06-2025 Latest Revision Date Approved by Bridge Engineer	 Standard Design	
	Steel Overhead Sign Truss September, 2011	
	DMS Runway Details 50'-130' Spans	SOST-12-11

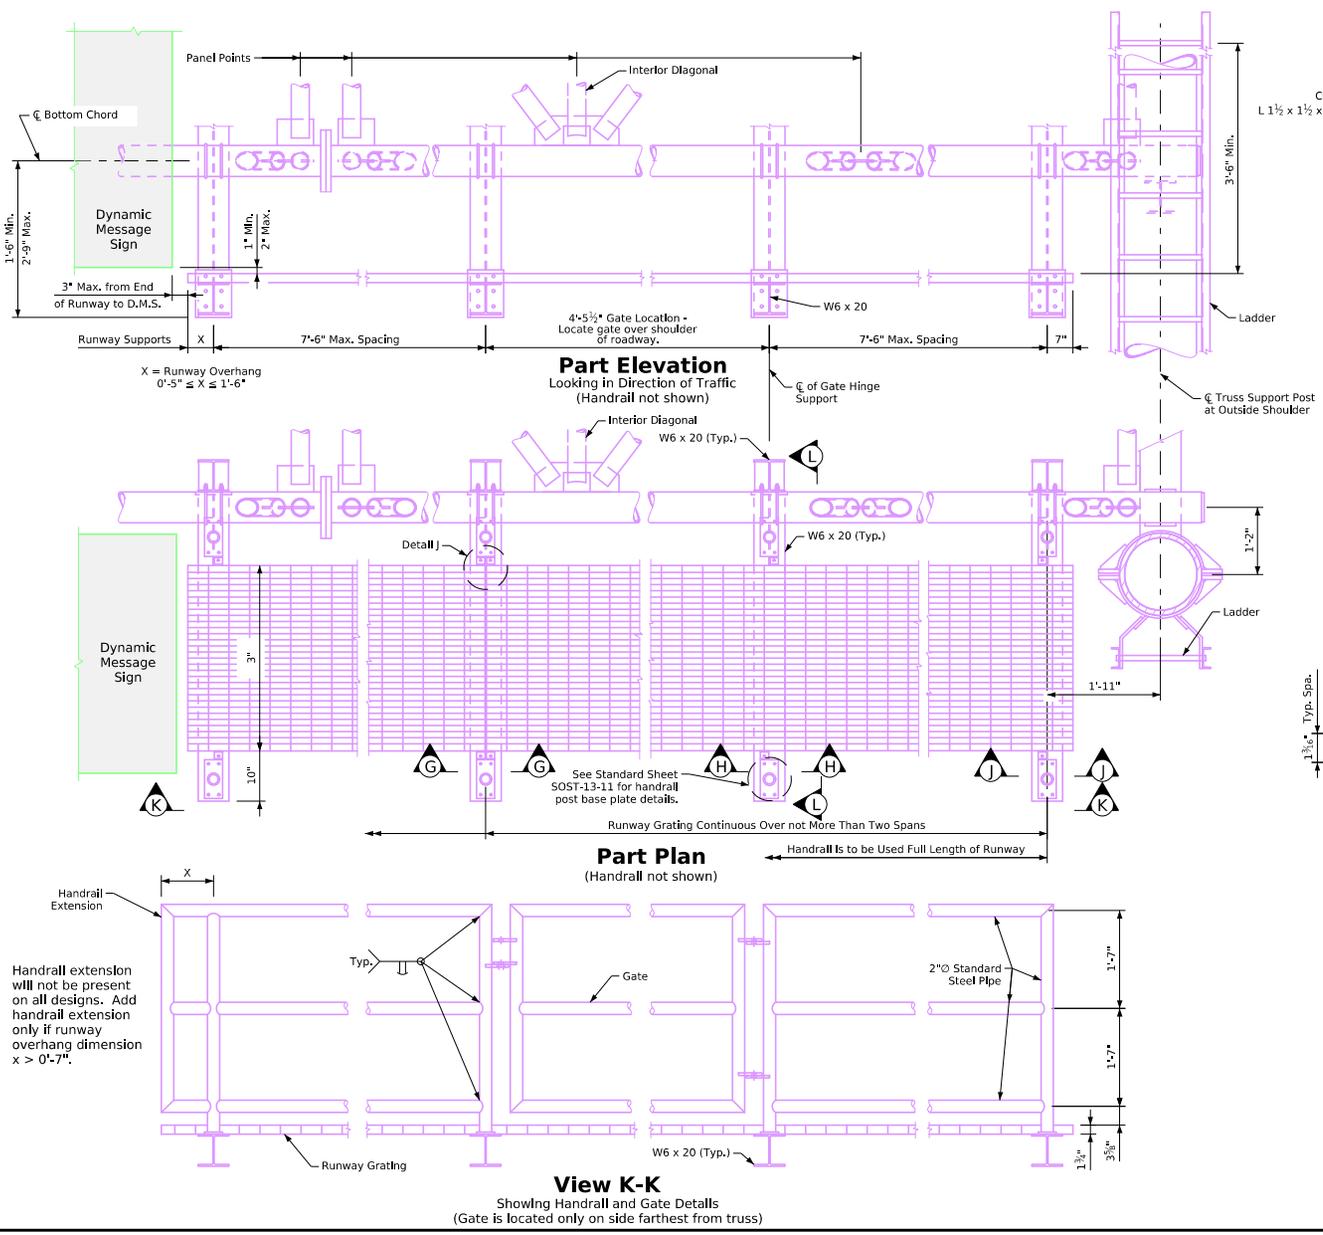
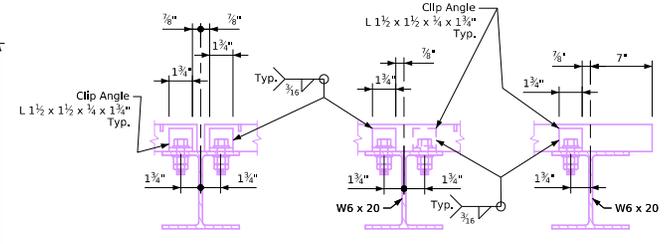
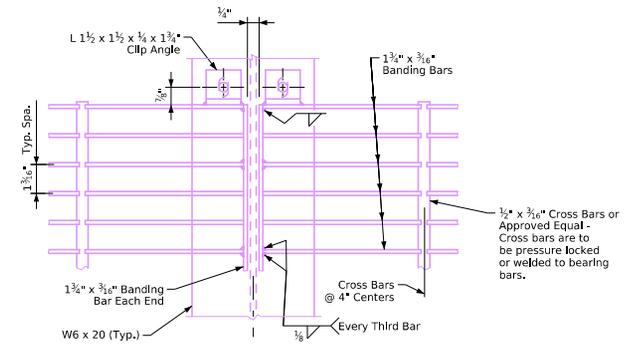
Revised 06-2025: Changed maximum cantilever length of DMS runway support bracket vertical W6 x 20 member from 2'-6" to 2'-0" to match dimension of SOST-13-11 typical runway section. Changed width of handrail gate opening from 4'-8" to 4'-5 1/2" to facilitate proper functioning of latch when gate is in open position. Removed dimension table for "W" (depending horizontal distance from ladder rung to front face of runway grating) as dimension "W" cannot be determined accurately until DMS cabinet size and mounting assembly dimensions are known. This sheet released, sheet format update.
 -steeloverheadsigntruss.dgn - SOST-12-11 - This sheet issued 03-2013.
